Project: Mankato to Mississippi River Project  
23-157

**Supplemental Information Inquiry 2**

Project: Mankato to Mississippi River Project  
23-157

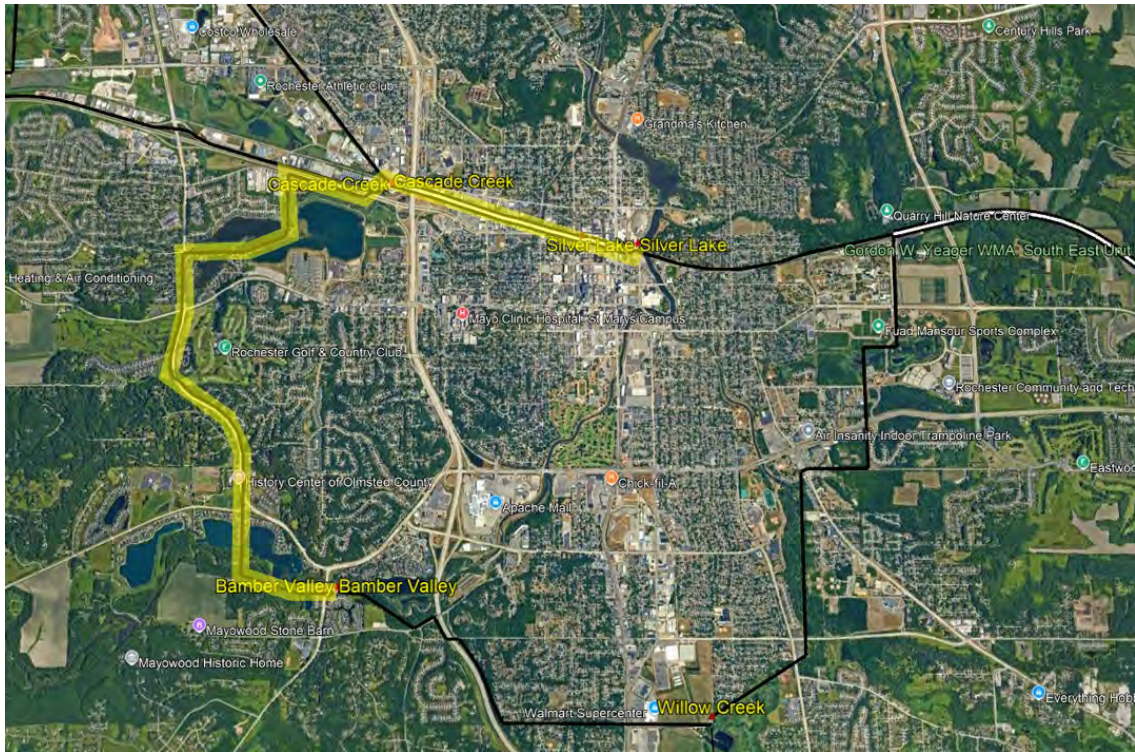
10. This question pertains to the Chester Junction Substation Alternative. In Xcel's response to EIS scoping comments, Xcel stated that three 161 kV lines would need to be rebuilt to a higher capacity to avoid overloads. Which three 161 kV lines, specifically, would need to be rebuilt to a higher capacity and what would that capacity need to be? Please provide a map or shapefile of their locations.

The line rebuild segments are as follows and shown in the screenshot below and attached shapefiles (ChesterJunction\_161kV\_Rebuilds\_20250124.zip)
